Milldale Stages 14 - 17

Consultation Summary

Fast-track Approvals Act 2024 Application

Figure 1: Wainui Road west of the development.

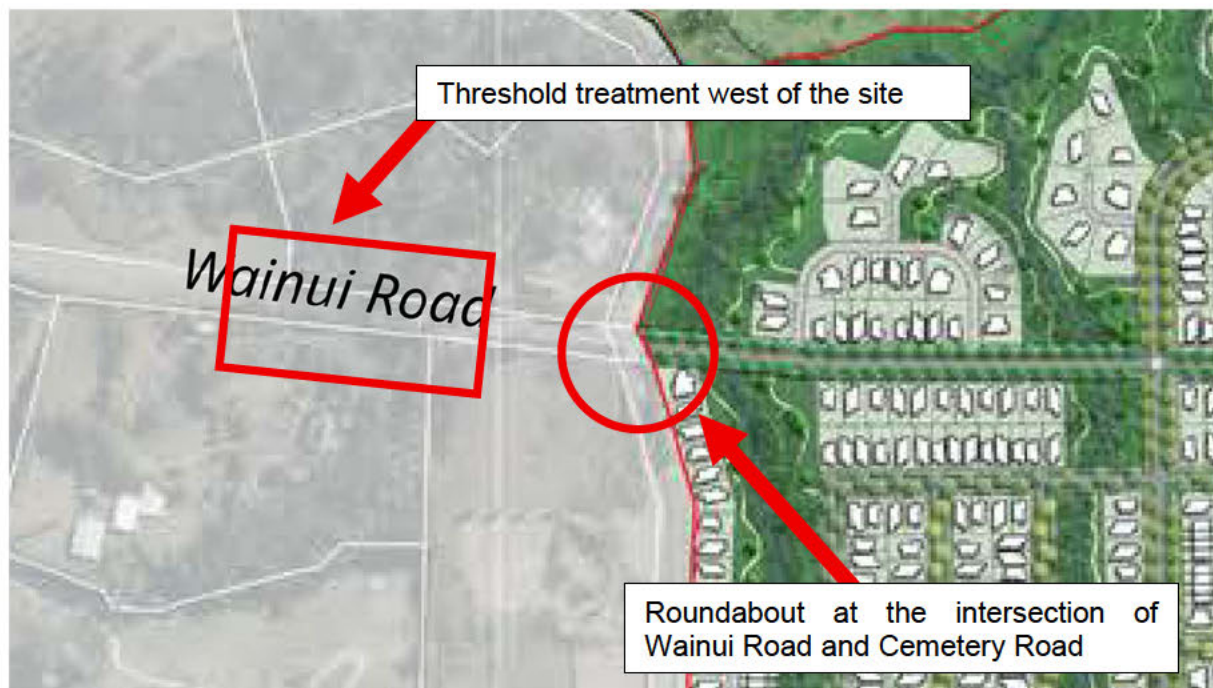
1. In order to slow drivers entering the site from the west via Wainui Rd a threshold treatment (signs, markings, kerbs, potentially landscaping) is needed on Wainui Rd to the west of Cemetery Rd to warn drivers that they are approaching an urban area and a roundabout will be needed at the Wainui Rd to the west of Cemetery intersection to physically slow traffic at the edge of the site. Refer Figure 1.

Figure 2: Example of potential compact roundabout (red) and mini-roundabout locations (blue).

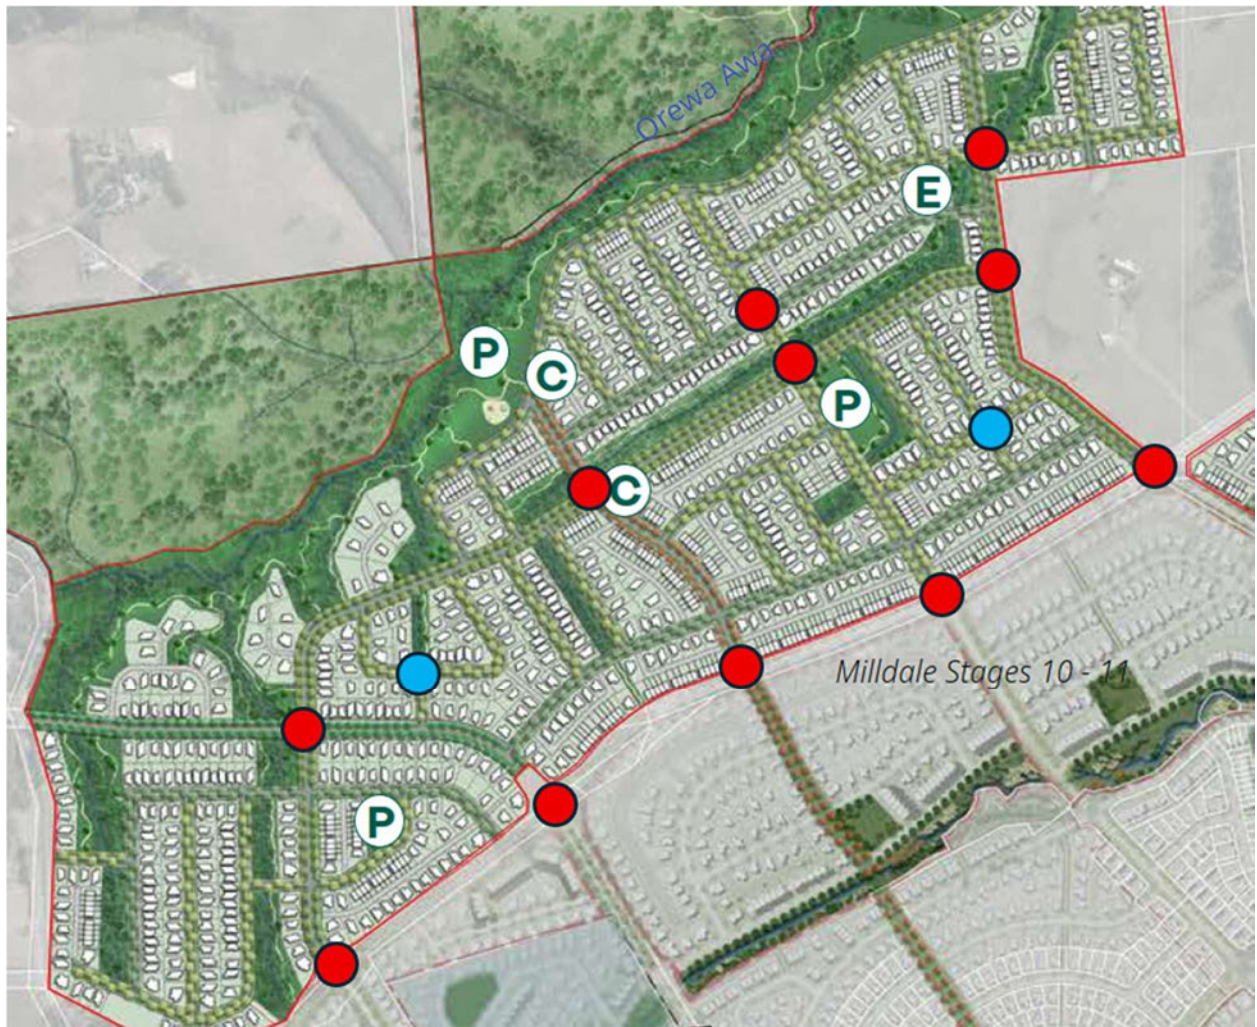
8. Where crossroads are proposed the preferred intersection treatment is a roundabout. For intersections on collector or arterial roads a compact roundabout design (where the central island has a mountable apron but is not necessarily fully mountable) is appropriate. Where the intersection is of two local roads a mini-roundabout design with a fully mountable central island is appropriate. I have marked up potential locations for roundabouts in the northern part of the site in Figure 2 as an example.

9. Milldale Central to the south and east of the site has many examples of both compact and mini-roundabout designs which can be adapted for the Milldale North and West site

Figure 4: Example of a Y-shaped intersection.

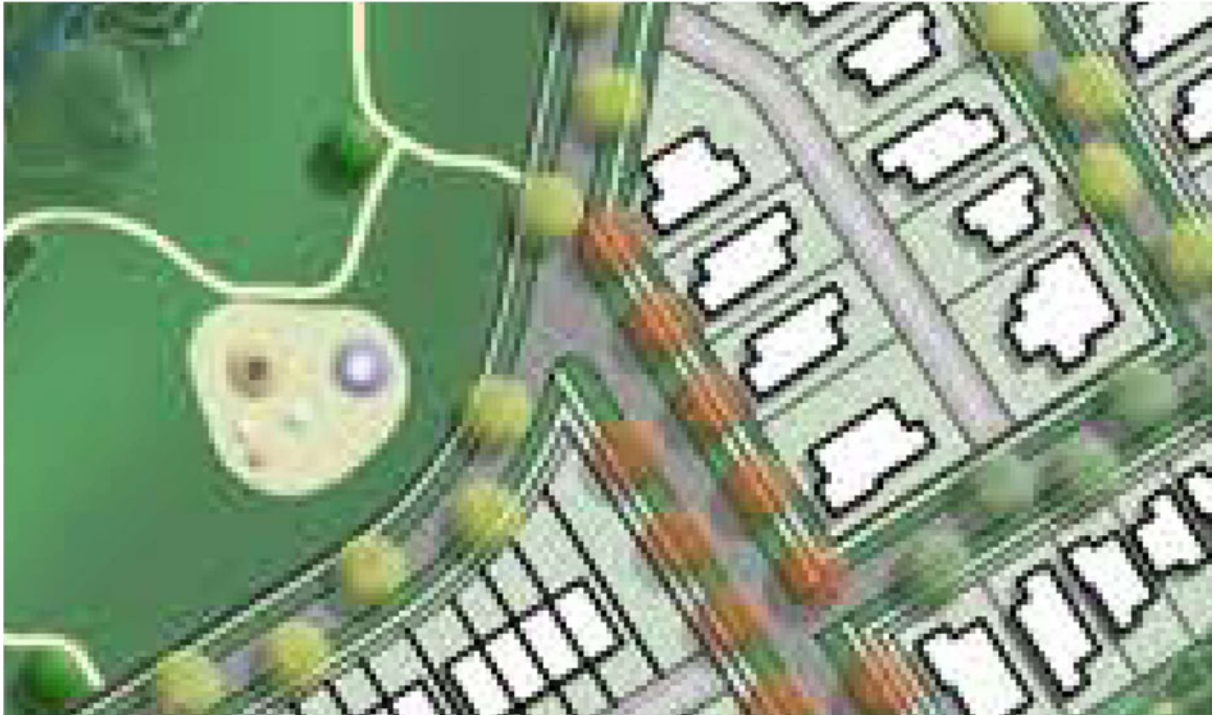
12. The masterplan is showing a number of intersections where the roads intersect at an angle which is not 90 degrees (plus or minus 10 degrees). This typically results in a wider intersection for truck tracking, longer crossing distance, higher vehicle speeds for some movements, a poor viewing angles for drivers.
13. Where intersections at angles other than right angles cannot be avoided a roundabout is the preferred type of intersection.
14. Some examples of this are shown in the figures below.

Figure 7: Example of driver sight distance from intersection limited by curve.

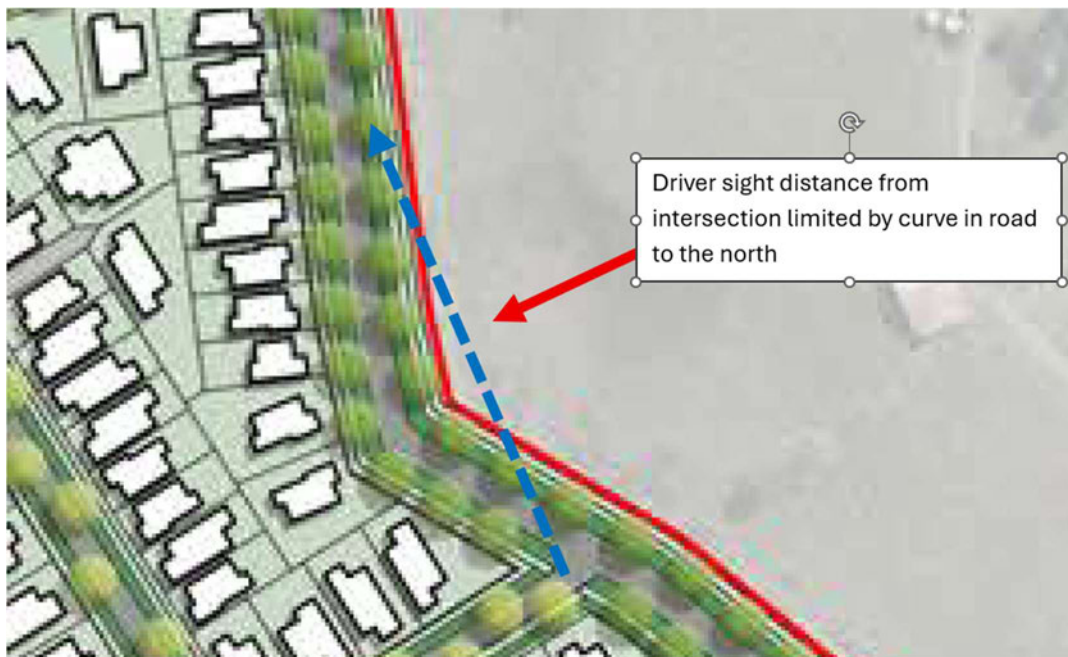
15. Intersections should be positioned away from curves in order to ensure that engineering standards (specifically Austroads Guide to Road Design Part 4A Safe Intersection Sight Distance) requirements can be met.
16. I have shown some examples of potentially problematic intersections from the master plan below.

Figure 1: Potential wetlands shown in green polygons

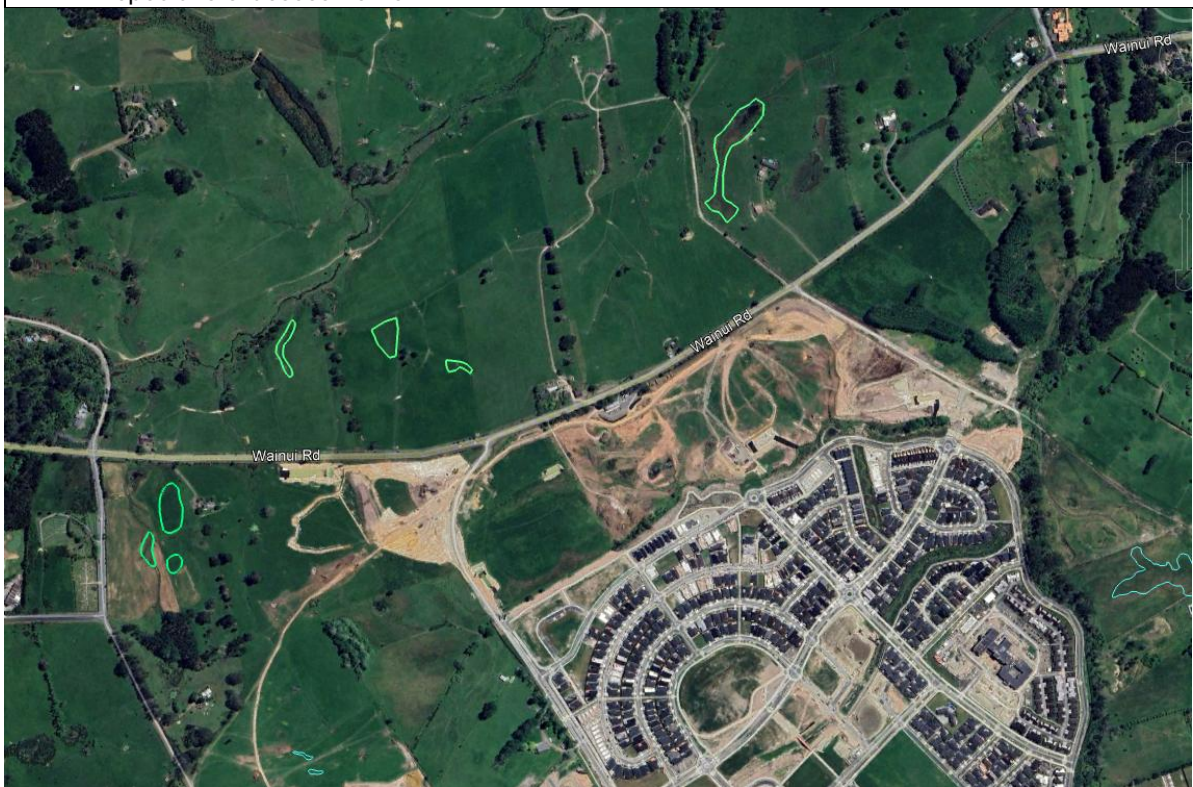
- Confirmation of wetland extent in areas noted as potential wetlands (refer to Figure 1 below). Wetland delineations should follow prescribed MfE protocols.
- An assessment presenting proposed offsetting to account for the permanent loss of wetlands resulting from this application must provide supporting hydrological data from which to confirm that a new wetland will be able to be achieved in perpetuity.
- I note that erosion in some streams has been discussed. The effects assessment should consider how erosion and consequent loss of stream value will be managed in the context of altered catchment hydrographs. I further note overlap with Council's fluvial geomorphology and stormwater specialists' assessments.
